PLANNING DIVISION STAFF REPORT

November 7, 2022

Project Address: 6706-6714 Odana Road

Application Type: Demolition Permit, Conditional Use, & Certified Survey Map Referral

Image 1: A portion of the Odana Area Plan’s [Path, Pedestrian, and Bicycle Network Improvements Map](#). (The subject site is highlighted)

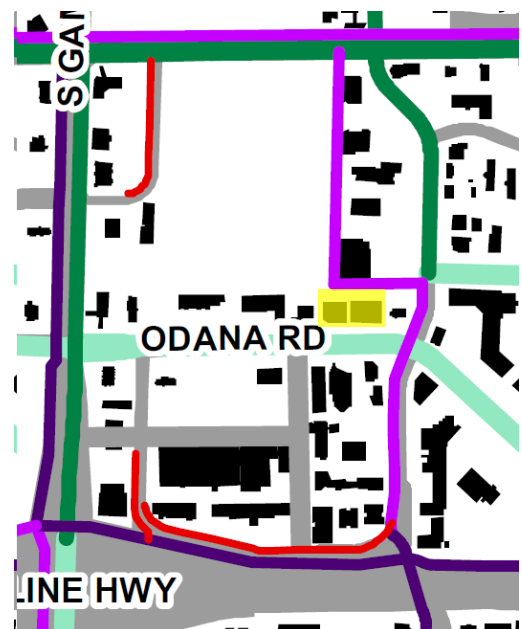
The [Odana Area Plan](#) also recommends a Planned Off-Street Path be constructed along the subject site’s northern property boundary. It will become part of the path which is planned to start at the bend in Grand Canyon Drive adjacent the Beltline, run along Grand Canyon Drive, jog west along the northern edge of the subject parcel, turn north near the northwest corner of the subject parcel, and continue up to the intersection with Mineral Point Road. (The path is shown in the fuchsia-colored line running north-south in the image to the right. The subject parcel is highlighted yellow.) To this end, as easement widths are typically 20’ wide for paths, since the path will straddle the property line, agencies have recommended the

applicant grant a 10-foot-wide easement for the pedestrian and public path along their northern lot line. Note: staff met with the applicant shortly before completion of this staff report to discuss possible forthcoming site plan modifications to accommodate this easement. A condition of approval has been added to this report, noting a revised site plan will be required for full staff approval to accommodate this recommended easement.

1. The applicant shall submit revised plans accommodating the 10-foot property line along the northern property line. These shall be reviewed and approved by City Agencies prior to final signoff.
